AGENDA ITEM 4D

**Waiver, Revised Preliminary Plat, Final Plat,
and Public Hearing on Planned Unit
Development Site Plan and Conditional
Use Permit – Woodhouse Place – LB
Southwest Investments, LLC**

RECOMMENDATION REPORT

CASE NUMBER: PSPP-17-0001
PSFP-17-0001
PPUD-17-0001
PCUP-17-0001

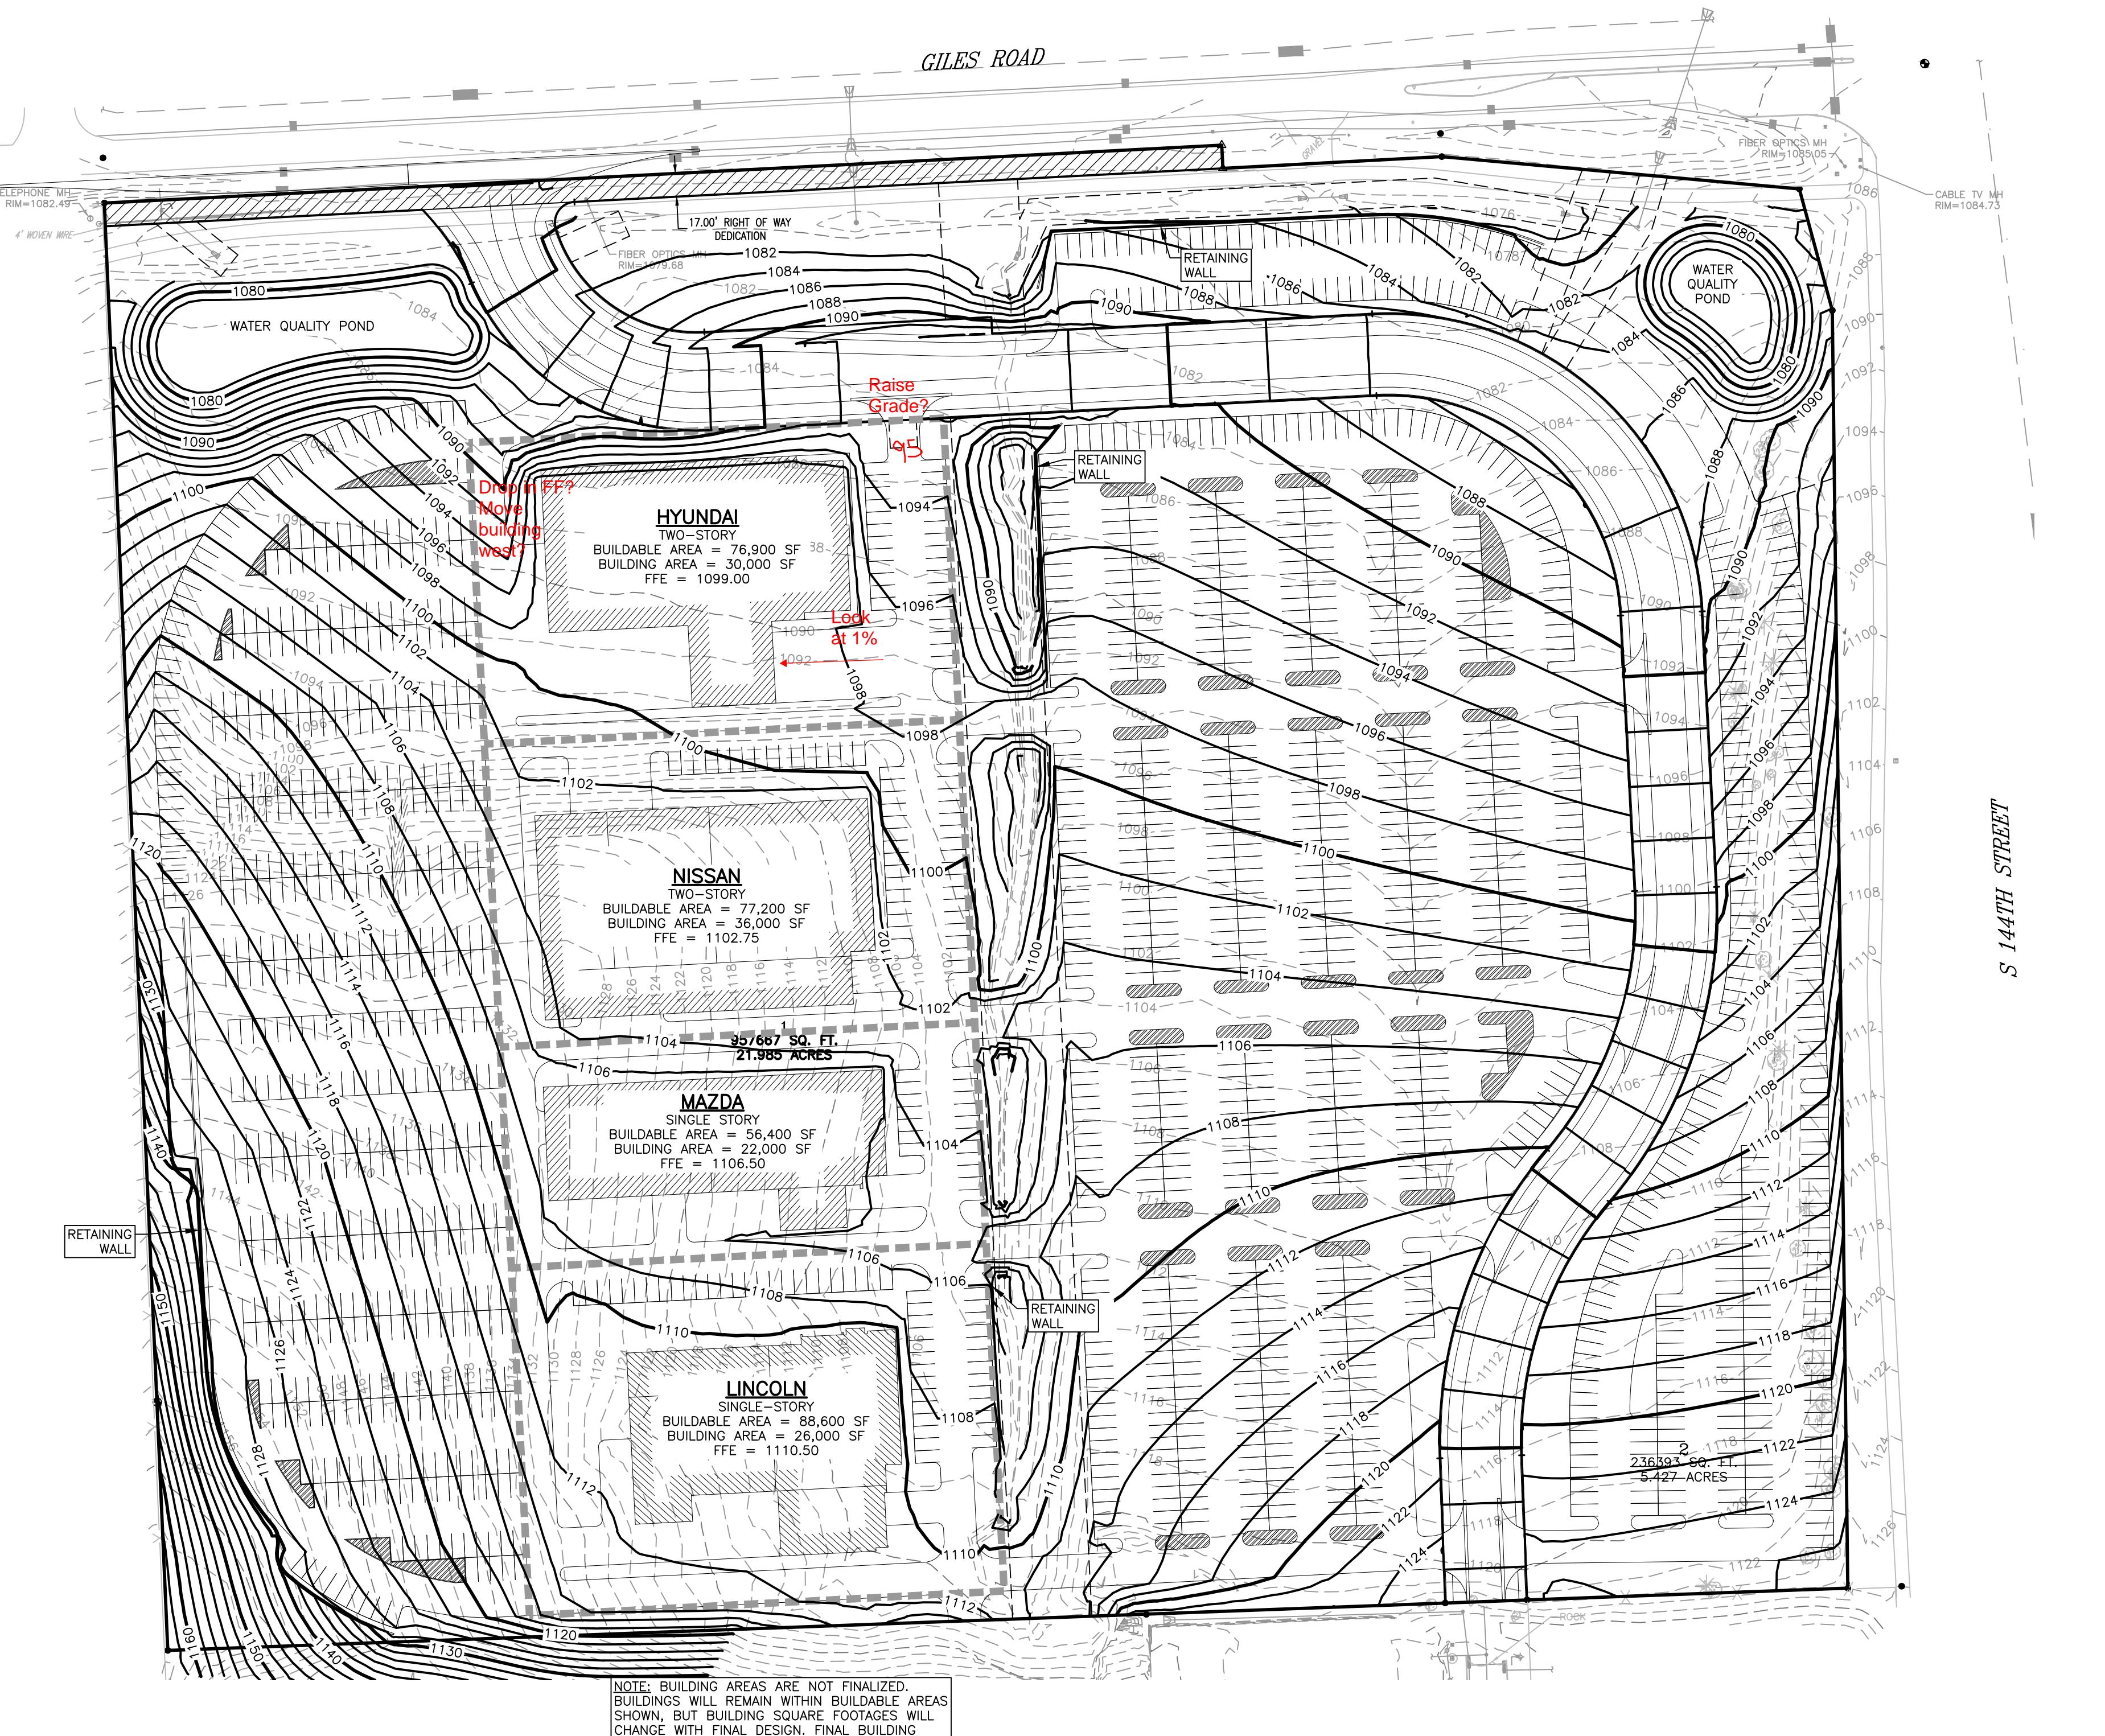
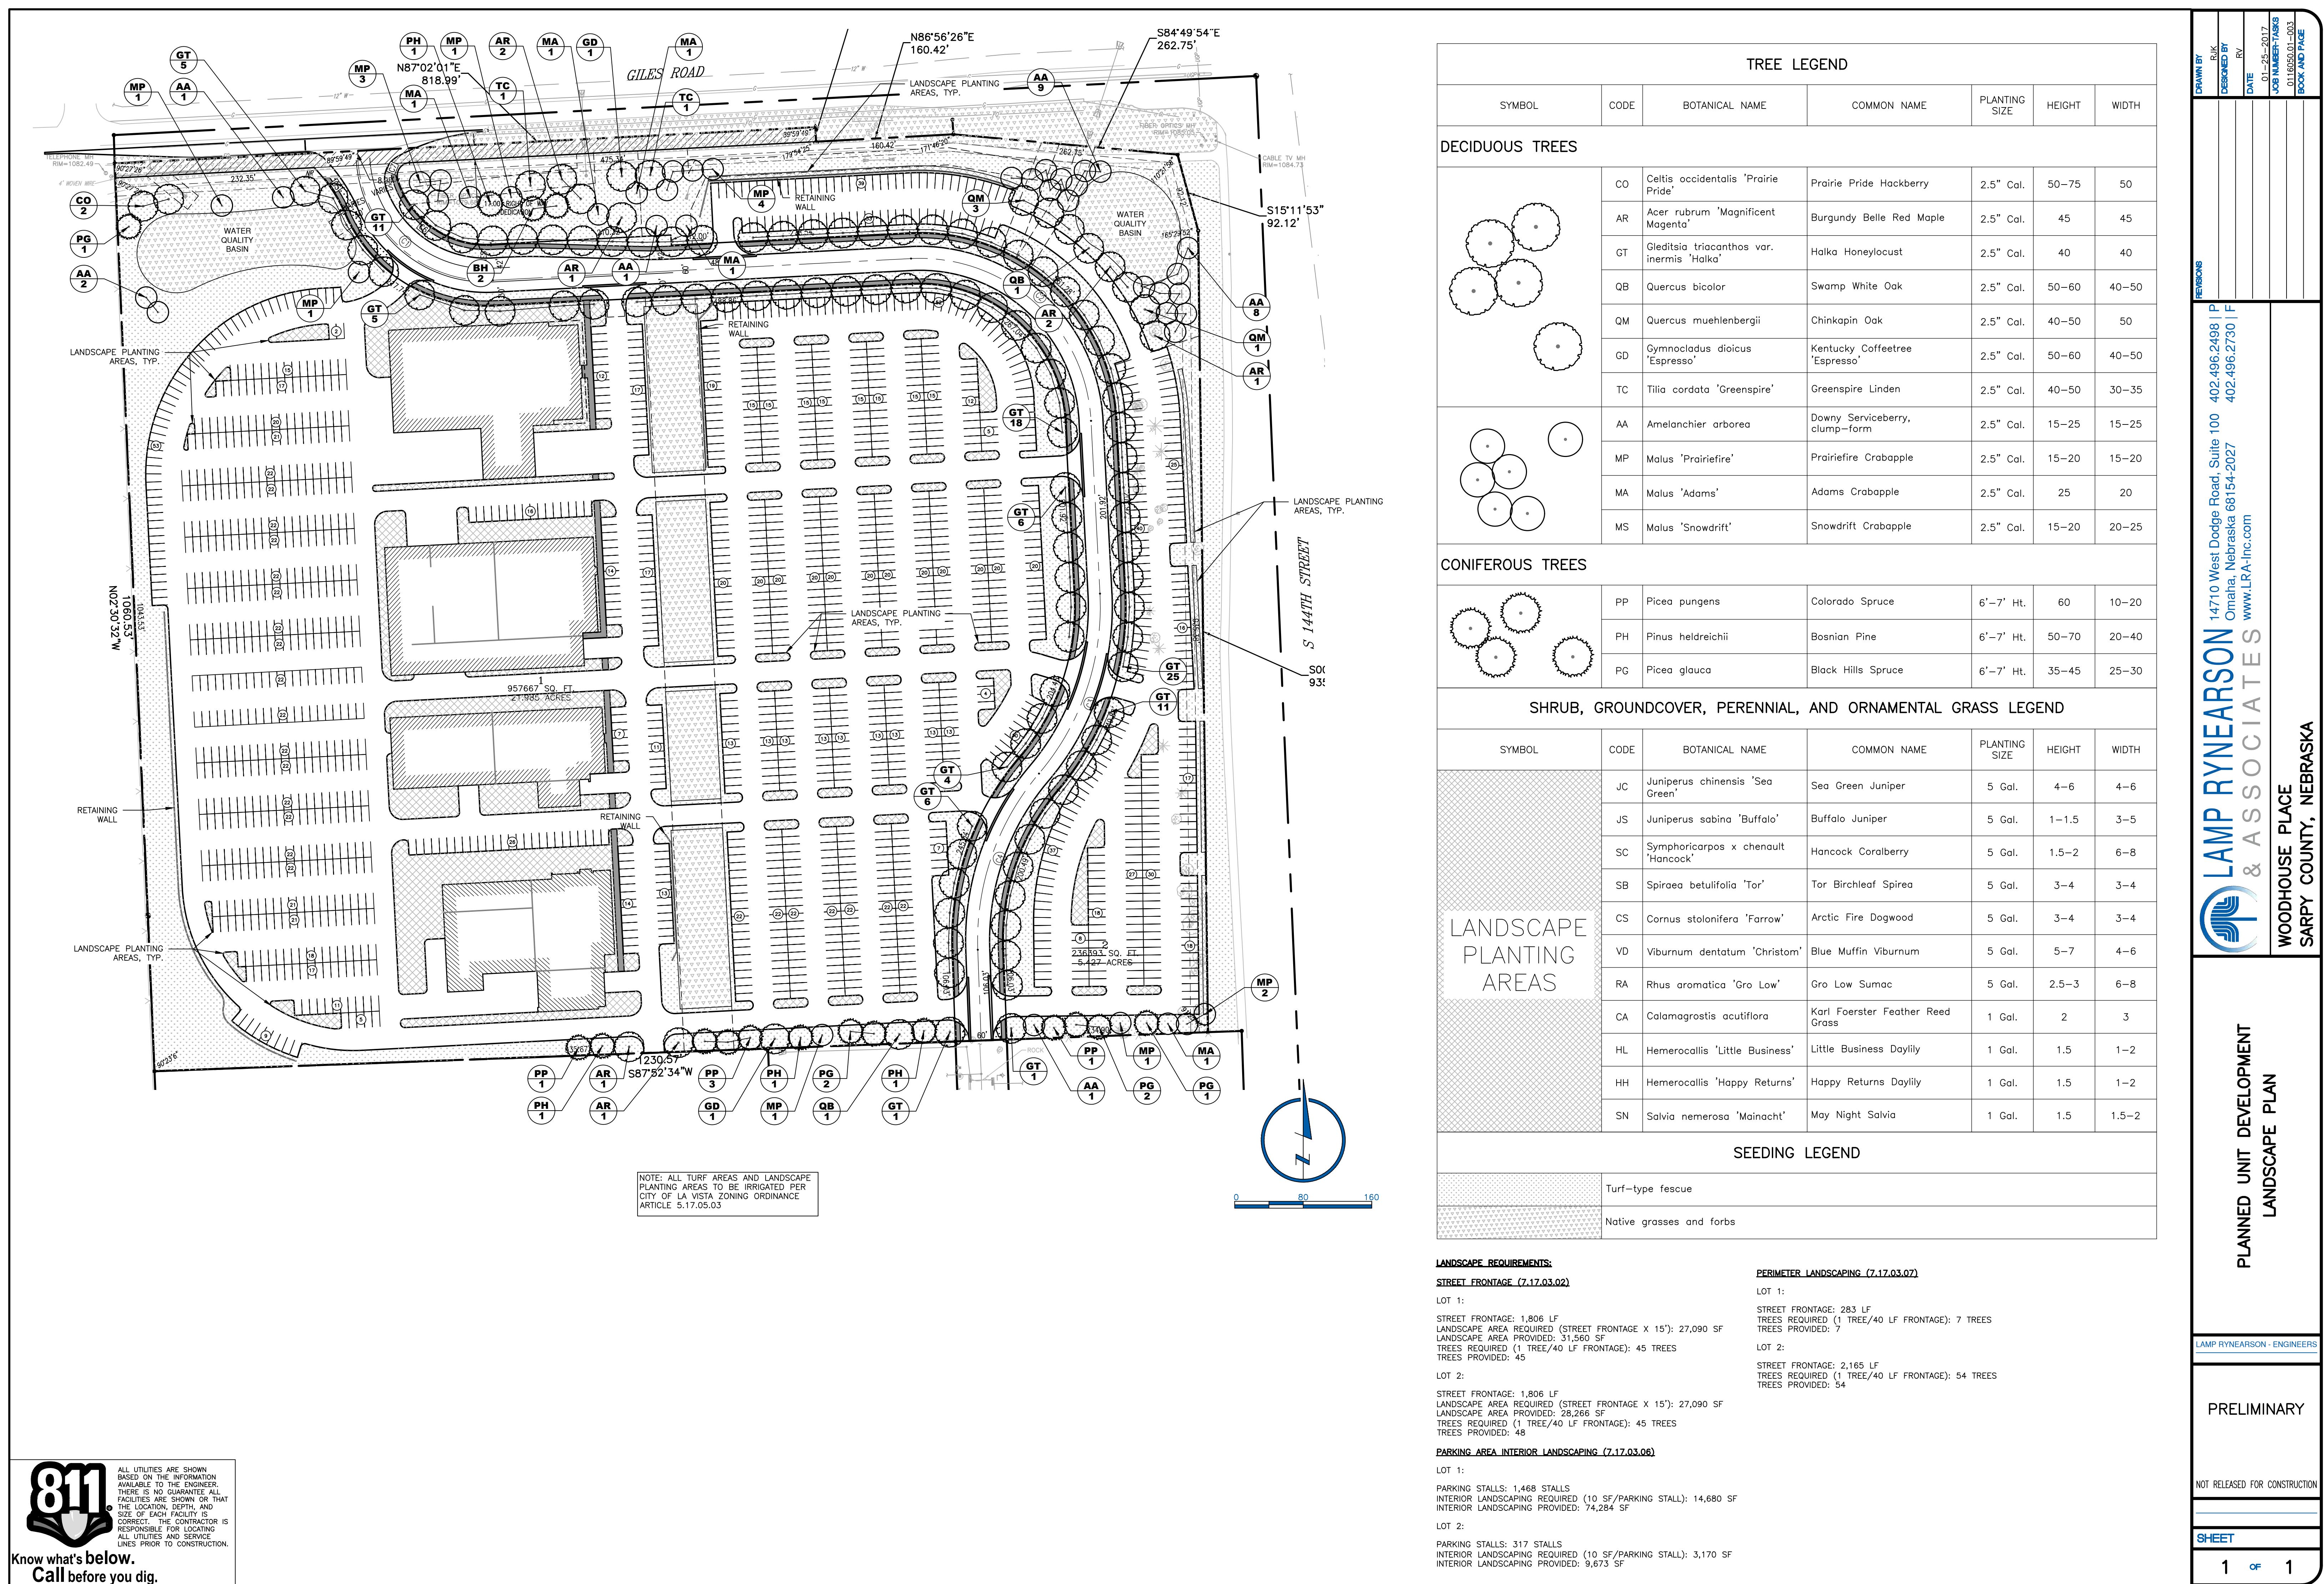
2. **Comment:** The PUD Site Plan lists the zoning as C-3. However, the zoning is C-3 with a Gateway Corridor District overlay.

3. **Comment:** In five locations, the PUD Site Plan notes "approximate sign locations". However, the approximate locations appear to be somewhere within the minimum setbacks for monument signs. Clarity on the proposed setback of the signage of the monument signs needs to be added to the site plan.

4. **Comment:** The northernmost note for the approximate sign location has been discussed to be a "Center Identification Sign", the site plan needs to be noted as such. Also, there should be enough room for this sign to meet required setbacks.

5. **Comment:** The remaining four sign locations are believed to be a single-tenant "Monument Sign" design. Please note the site plan with this designation. Each sign should be tied back to their corresponding building through a notation on the site plan.

8. **Comment:** Also related to Article 5.15.04.06, it appears that paint-striped islands are proposed within the interior of the large parking lots. These islands need to be landscaped.

9. **Comment:** The labeling of the "Planting Bed, Typ" area call-outs should match that of the "Landscape Planting Areas" key title. Planting beds should continue along the retaining wall along the northern portion of the parking lot (Giles facing) on Lot 2 to soften the look of the retaining wall.

12. **Comment:** In regards to Article 5.15.04.09, there needs to be included a statement that there will be no buildings on Lot 2.

13. **Comment:** Relative to Article 5.15.04.12 please address the ownership and maintenance of Lot 2. It should be the same as the ownership and maintenance of Lot 1.

14. **Comment:** Identify by notation on the PUD Site Plan that sidewalks are proposed to be constructed along 145" street.

15. **Comment:** In regards to Article 5.15.05.02(4), consideration should be given to sidewalks that connect the buildings to the proposed public sidewalks and the hiking/biking trail.

16. **Comment:** A vicinity map needs to be added to the PUD Site Plan to meet the requirements of Article 5.15.05.06

Response: The PUD site plan has been updated to show correct zoning.

Response: Proposed signage setbacks have been added to the PUD site plan.

Response: Sign noted as center identification sign on the site plan. Proposed signage setbacks have been added to the PUD site plan.

Response: Monument sign has been designated on their site plan and tied back to corresponding buildings.

Response: The islands have been revised to be as landscaped on the site plan. During final design, we would like to review the island layouts with the City and potentially reduce islands or paint some of the internal islands to assist with snow plowing while still meeting the interior landscaping requirements.

Response: Labeling has been modified to match.

Response: A statement that there will be no buildings on Lot 2 has been added to the site plan.

Response: A note addressing ownership and maintenance of Lot 2 has been added to the site plan.

Response: A note has been added to the site plan regarding sidewalks.

Response: Sidewalk has been added to connect buildings. Although sidewalks connecting the buildings to the public sidewalk along 145th Street are shown on the revised Site Plan, the extent and layout of the sidewalk will likely be modified with the final building footprints and building permit submittals.

Response: A vicinity map has been added to the site plan.
